**Arboricultural Impact Assessment
Young High School - Main Works 2019 V1**

This report covers part 2 - Young High Main Works which includes;

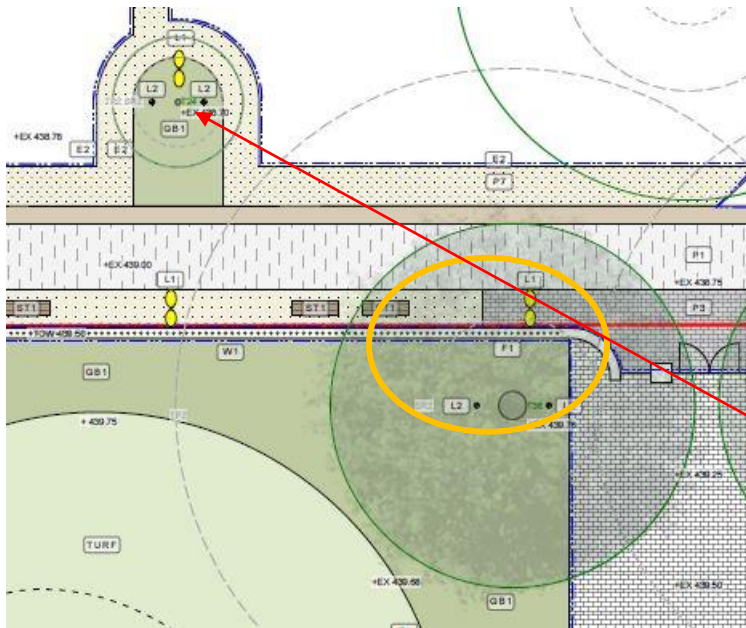
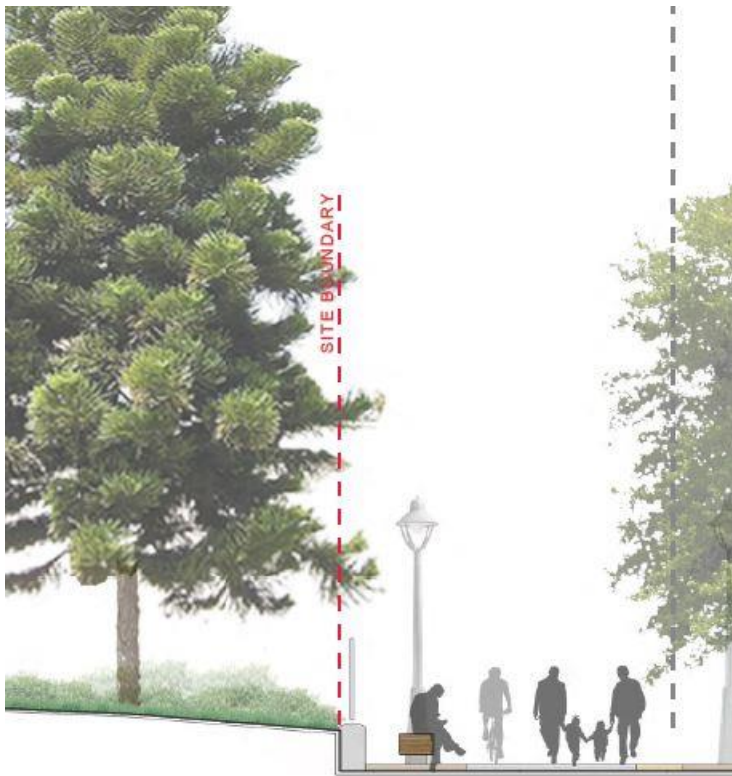
There is proposal for construction of concrete and granite pathways from the Olympic Highway west to the new Library entrance – under the canopy of trees 33, 36 and 37 to the edge of the structural root zone of the trees. The design needs to be such that excavation into the current soil does not occur. The pathway needs to be raised above the current soil level to prevent the severing of root systems. Excavation this close to the stems will not be an acceptable encroachment to the trees. Current root systems will extend well into Carrington Park and well past the TPZ.

Diagram 3 – Extract from Landscape plans – pathway area constructions to edge of structural root zones of trees 33, 36 & 37 – Orange circle depicts how close to the stem the potential impact could be relative to Tree 36 as example. The design needs to prevent excavation into current soil levels.
Tree 24 – Reconciliation tree

Depiction of
proposed pathway –
red line of site
boundary is the
location of the
structural root zone
of trees 33, 36 & 37.

Design and
construction is
critical for tree.
